CITY OF RAYMORE

ADDENDUM NO. 1

Willowind Gravity Sewer
Project #20-345-201

Addendum No. 1 - Clarification and questions.

Engineering Department City of Raymore 100 Municipal Circle Raymore, MO 64083 816-331-1852 Fax 816-331-8067		<h1>City of Raymore</h1>			
		<h2>Pipe Encasement Under Road</h2>			
DRAWN Modified 2013	DATE	SIZE A	FSCM NO.	DWG NO. St - 13	REV
CHECKED		SCALE NONE		SHEET 1 OF 1	
APPROVED

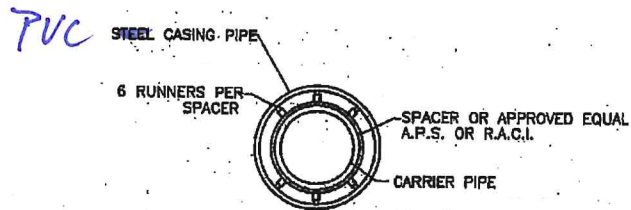
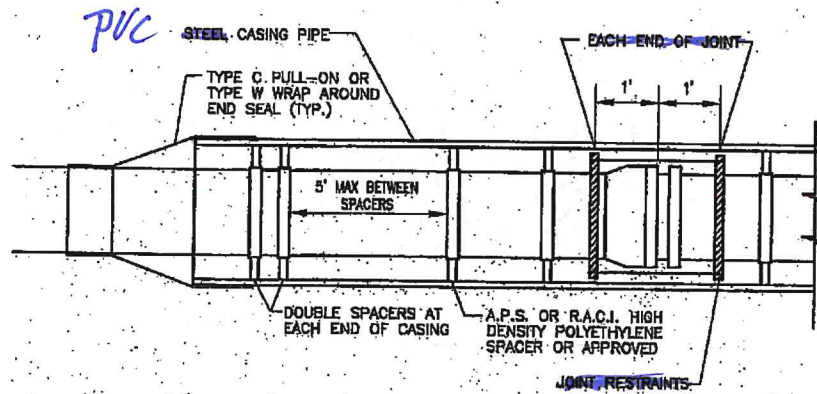
1. The City has no data on the amount of sewage currently flowing into the wet well.
2. The City has no information on the subsurface conditions below 58 Highway. The bore should be considered unclassified.
3. The carrier pipe in the bore shall be either restrained SDR 26 or Restrained C900 PVC.
4. The casing detail is attached. External joint restraints are not required and the casing pipe is to be C905 PVC.
5. What is the restoration requirement? Seed and Straw? What is the restoration requirement on the North side of 58 Highway?

1. Engineer to determine required casing pipe thickness.
2. Polywrap required if the casing pipe is ductile iron.
